SUBSURFACE WASTEWATER DISPOSAL SYSTEM APPLICATION

Street, Road, Subdivision
11 CAMPBELL RD

REPLACEMENT SYSTEM VARIANCE REQUEST

SUBJECT: Approval, Replacement System Variance Request, Nichols property, Portland

DISPOSAL FIELD LAYOUT

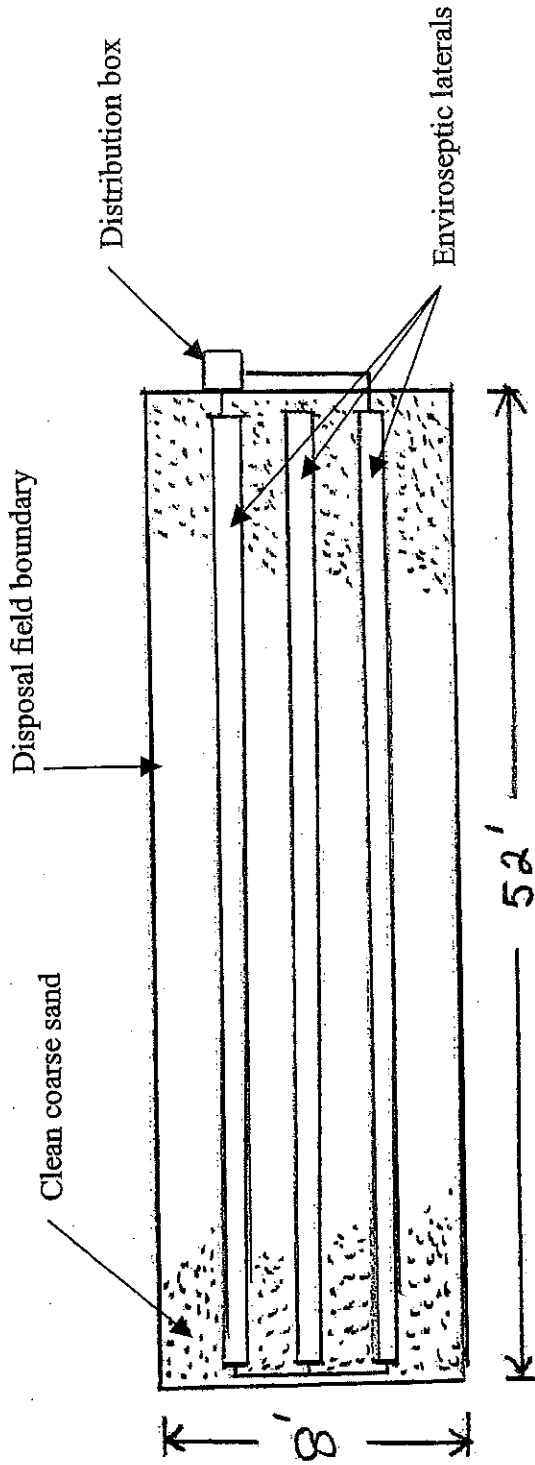
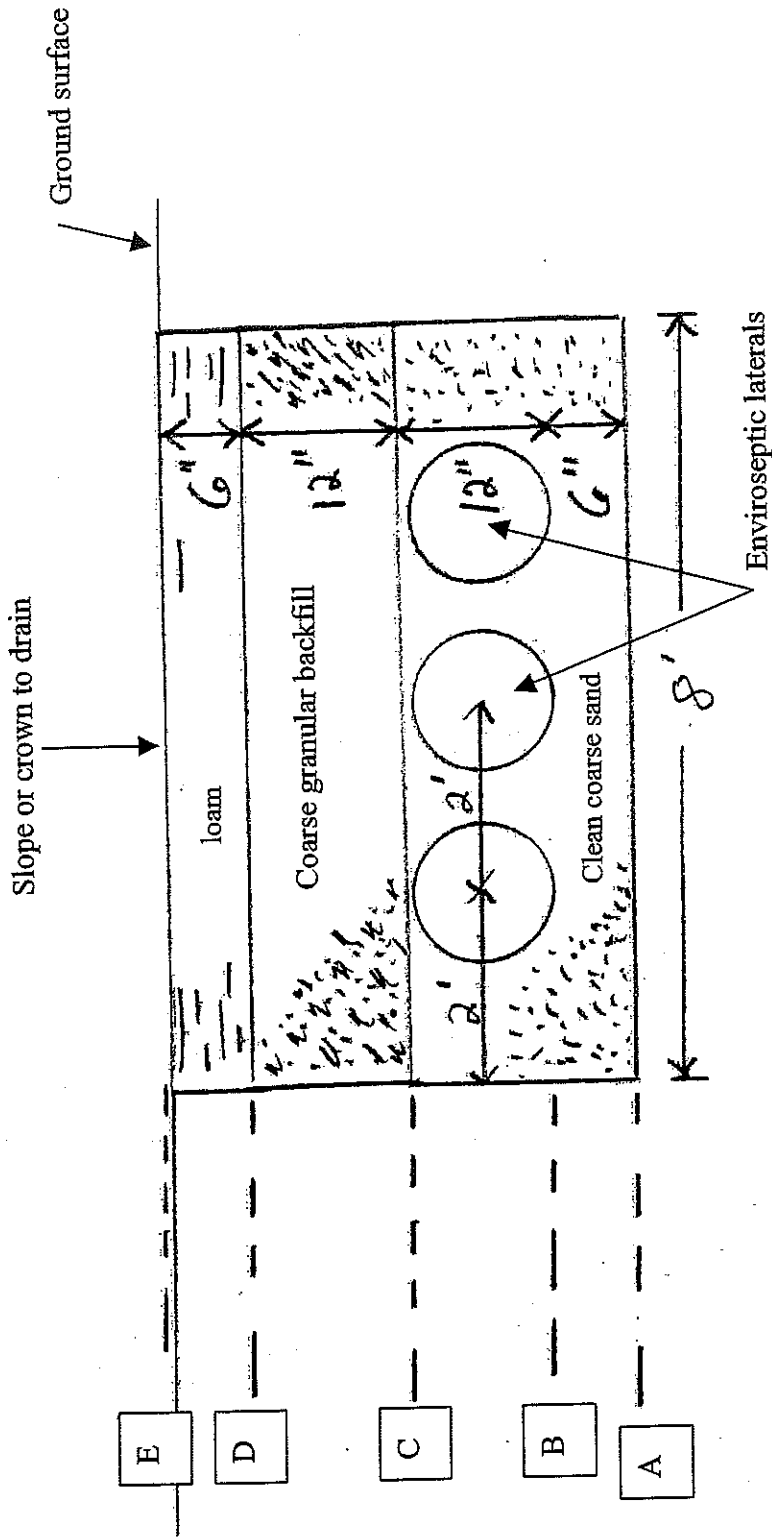
The Division has reviewed a replacement system variance request for the subject property. The state variance requested is to install the system with a setback distance reduction from a slab or a frost wall to the disposal field of six feet and a setback distance reduction from a property line to the disposal field of four feet. As we understand the situation, the variance request has been submitted because topography and existing development limit the potential system location. The system design prepared by Michael Deyling, SE, dated 07/08/2004 is otherwise found to be in compliance with the Maine Subsurface Wastewater Disposal Rules.

The attached proposed design places the system within four feet of our property line and therefore we respectfully request a variance to the setback requirement.

We approve the requested variance with the following requirements:

1. A permit for system installation is to be obtained from the Local Plumbing Inspector in advance of the start of system construction.
2. The system is to be installed in accordance with the submitted and approved system design. Should alterations to the design be required at the time of construction, the site evaluator is to be notified prior to making any changes.
3. The contractor is to scarify the soils under the fill extensions to create a transitional zone more compatible with the disposal field area.
